Application for Works Approval Amendment

Part V Division 3 of the *Environmental Protection Act 1986*

Works Approval Number	W6584/2021/1
Works Approval Holder	GMA Garnet Pty Ltd
ACN	009 344 227
File Number	DER2021/000422
Premises	Port Gregory Garnet Mine 1420 George Grey Drive Yallabatharra WA 6535 Legal description – Mining tenements M70/856, M70/204, M70/259, M70/926, M70/927, M70/968, G70/171, M70/1330 and M70/1331(excluding Lot 58 on Plan 65344)
Date of Report	10 March 2023
Decision	Revised works approval granted

Figure 1: Bioremediation Facility Layout

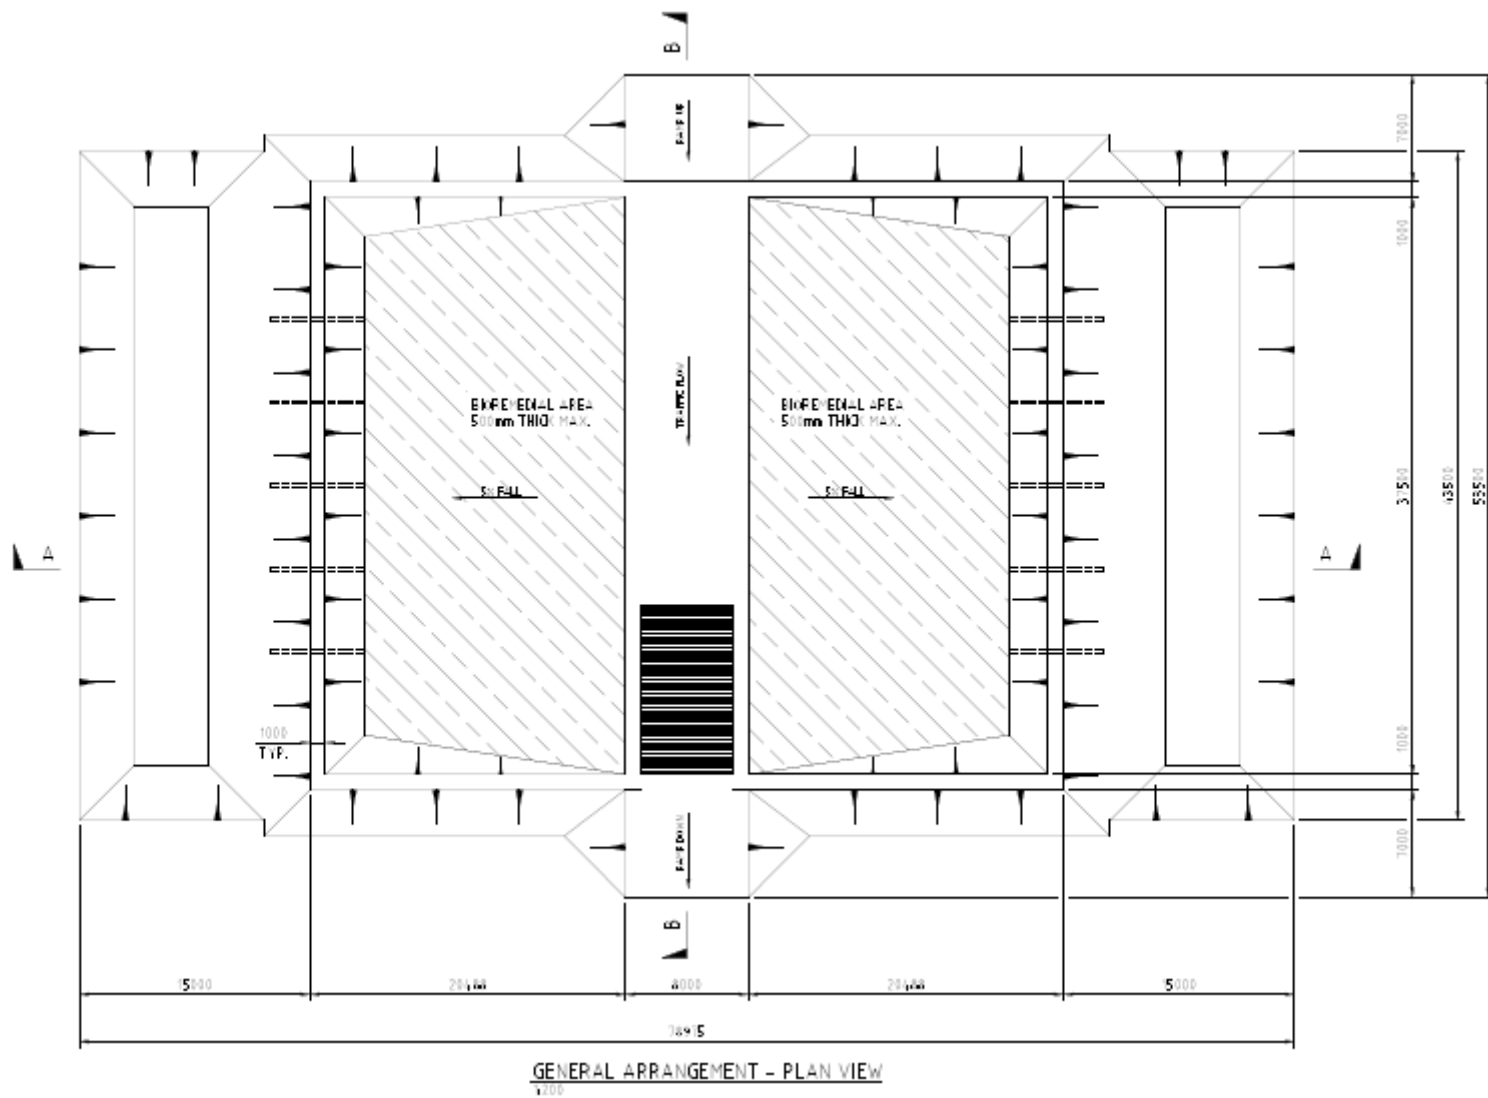
The Works Approval Holder has proposed to change the layout of the bioremediation facility, to orientate the entrance to the east instead of west as described in the original plan. The Works Approval Holder also proposes to remove the internal bunding from the design of the facility and replace it with a 1 metre earthen bund that will surround the whole facility to prevent stormwater access, giving the same level of protection from stormwater incursion as the original risk assessment. Changes will be made to condition 1 of W6584/2021/1 and Figure 6 will be replaced with Figure 1 below. The location of the bioremediation facility will remain unchanged and no additional emissions or discharges are expected from the proposed changes.

In the original assessment of W6584/2021/1, the Works Approval Holder supplied incorrect specifications and testing requirements for the liner to be installed at the bioremediation facility. The specification and testing requirements originally supplied were for a 2.0 mm thick liner. The proposed thickness of the liner at the bioremediation facility is 1.5 mm. Table 1 below shows the standard specification for high density polyethylene liners as described in the 2021 document *GRI -GM19a Standard Specification* (Geosynthetic Institute, 2021).

Schedule 1 – Figure 2: Location of the proposed Solar drying ponds and Bioremediation pads	<ul style="list-style-type: none"> Updated map showing indicative location of the Tailings transfer station
Schedule 1 – Figure 6: Bioremediation layout	<ul style="list-style-type: none"> Updated design map of the layout of the Bioremediation facility showing the change of design to the stormwater bunding
